# City of Frankfort

To: Architectural Review Board  
From: Jordan Miller, Senior Planner  
Re: Meeting – August 18, 2020

ARCHITECTURAL REVIEW BOARD

416 Capital Avenue  
Special Capital Historic District

2767 sq ft  
2 story on slab w/

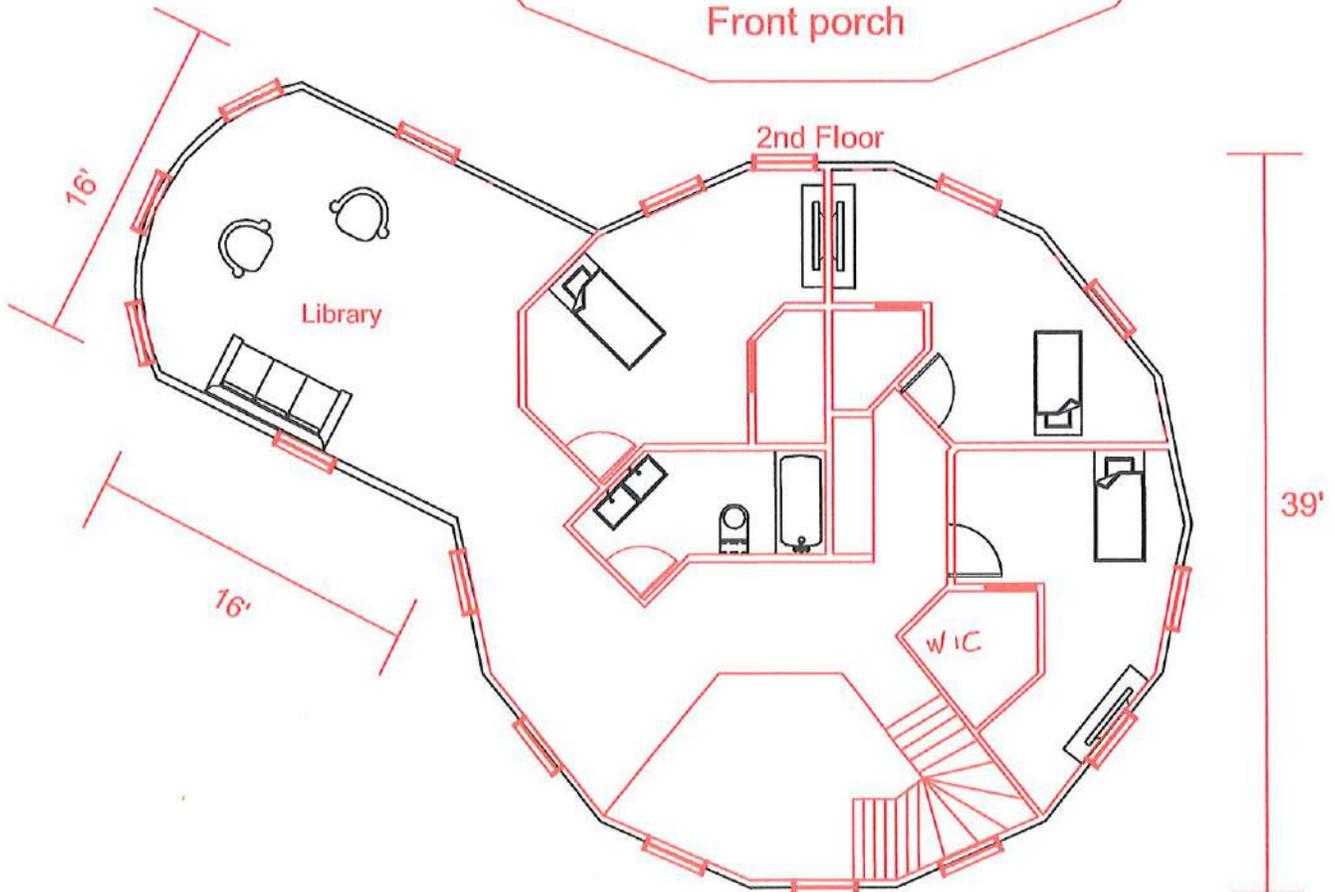
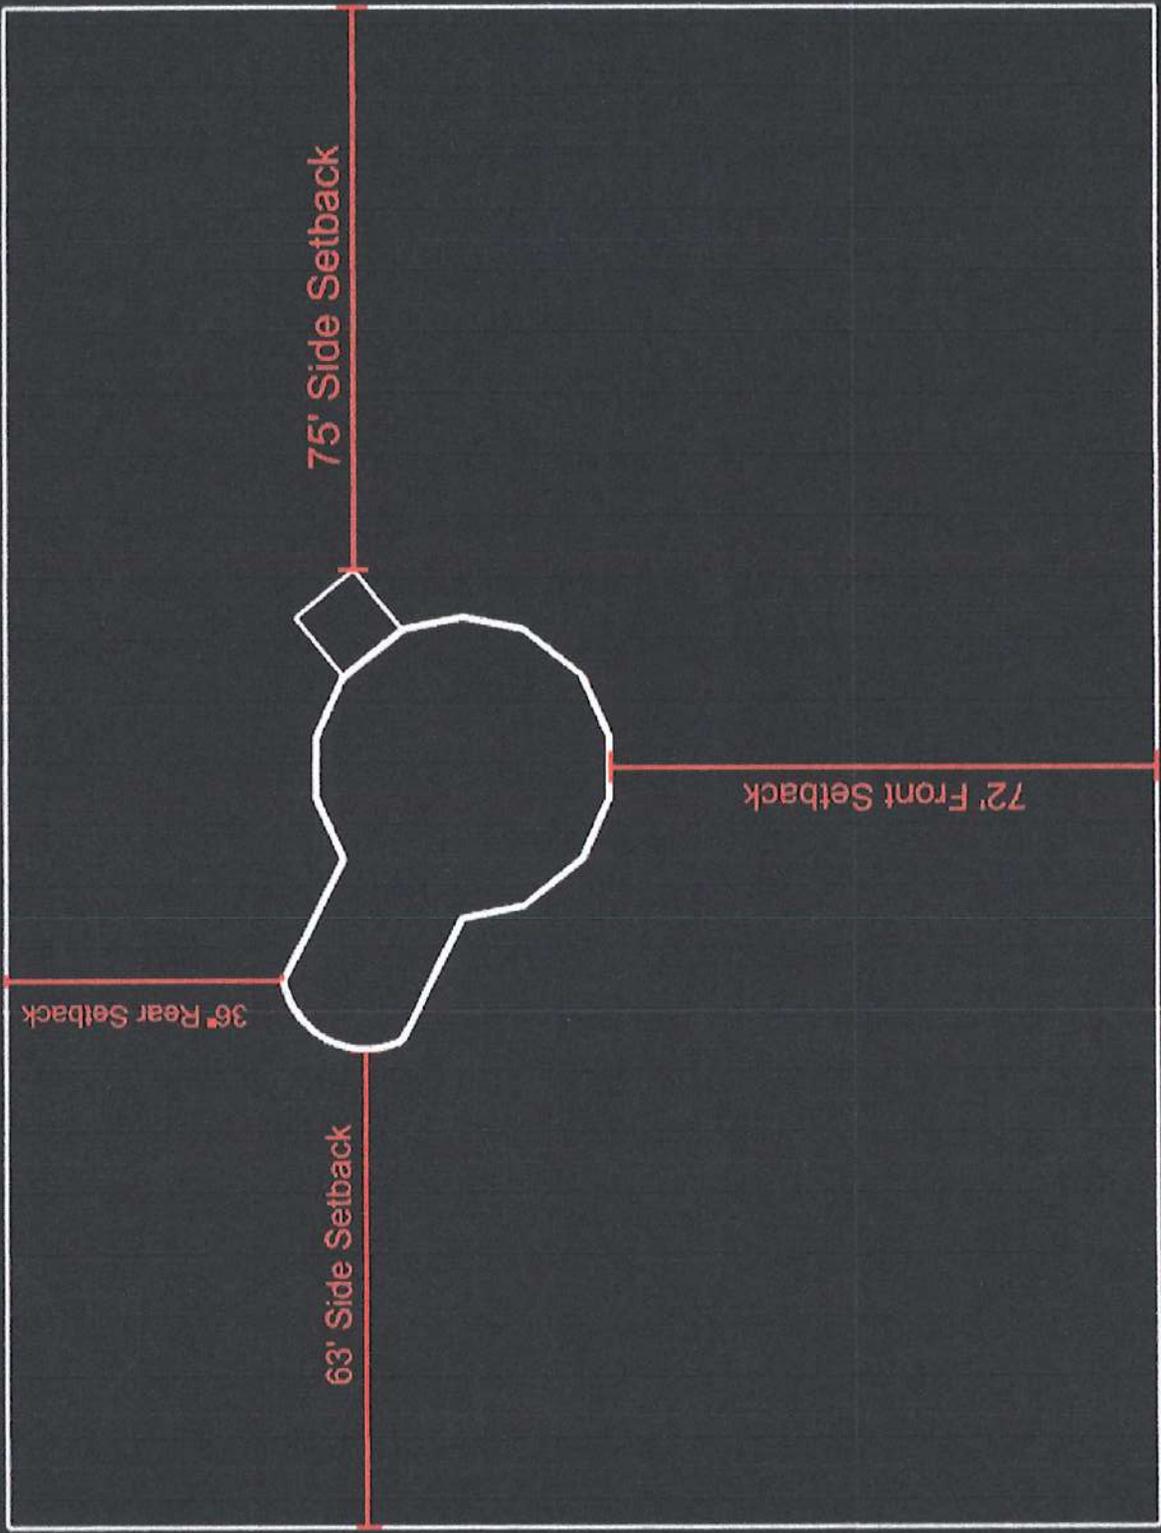
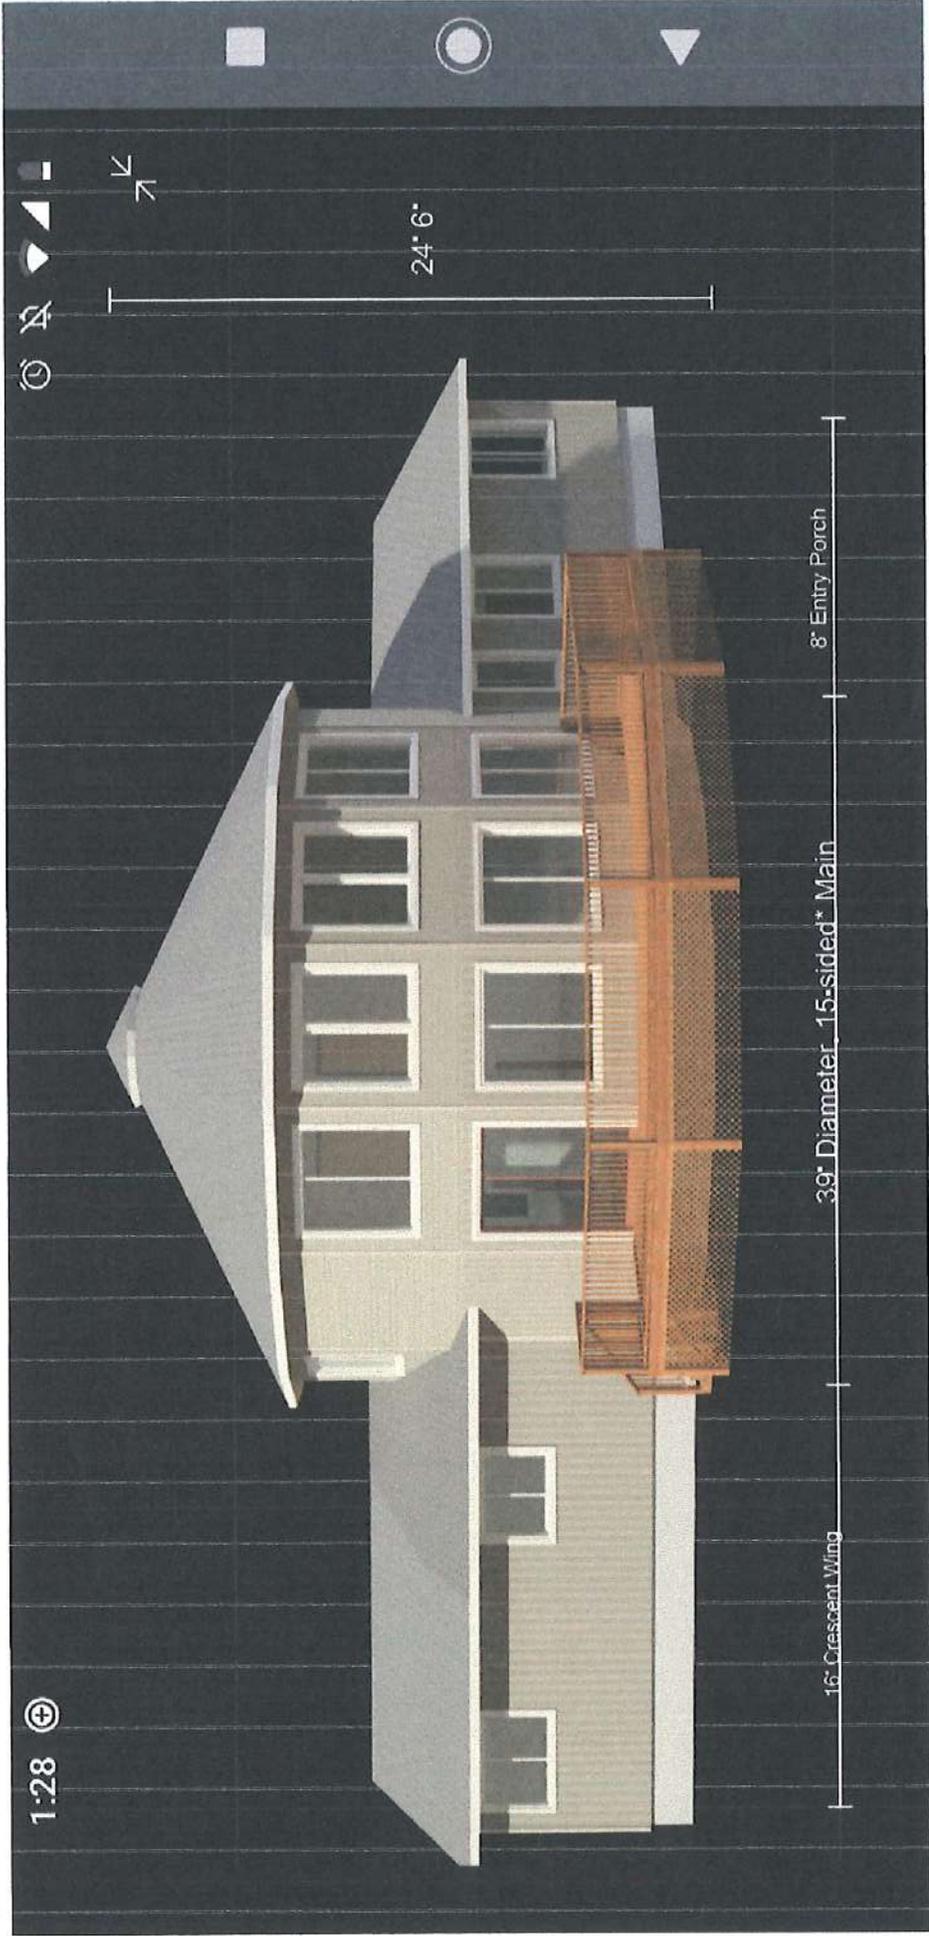
Mr. Miller explained that he wanted to address the pitch of the roof, he stated that it is noted that it is a 3/12 pitch which is not the pitch depicted in the photos that have been provided. What they are proposing is a much lower sloped roof and it is about as low as you can go with and still allow asphalt shingles to efficiently shed water. Staff would recommend that it have a higher pitch.

Mr. Miller also explained that staff would recommend a rendering be produced of the final proposal in the context of the lot to give us a better idea of what it would look like in the surrounding setting.

Mr. Miller stated that as far as materials they are proposing staff is in support of the wood windows, half-round gutters and downspouts. Mr. Miller stated that staff is recommending that the cement board siding be installed horizontally. Additionally staff would recommend that the deck be painted and concerning the 3'-4' overhang staff would recommend that the deck completely cover the porch. Mr. Miller mentioned that the wing closest to Capital Avenue is shown as a two-story but in the drawings it appears to be one-story. Mr. Miller stated that those are the items that staff would like to see flushed out.

1. This approval is preliminary and for the general design, shape, and siting of the proposed structure.
2. The applicant shall present final drawings and design plans to the Board after they have been completed by the architect.
3. No building permit shall be issued nor any construction begin stemming from this approval until the final design has been presented to and approved by this Board.
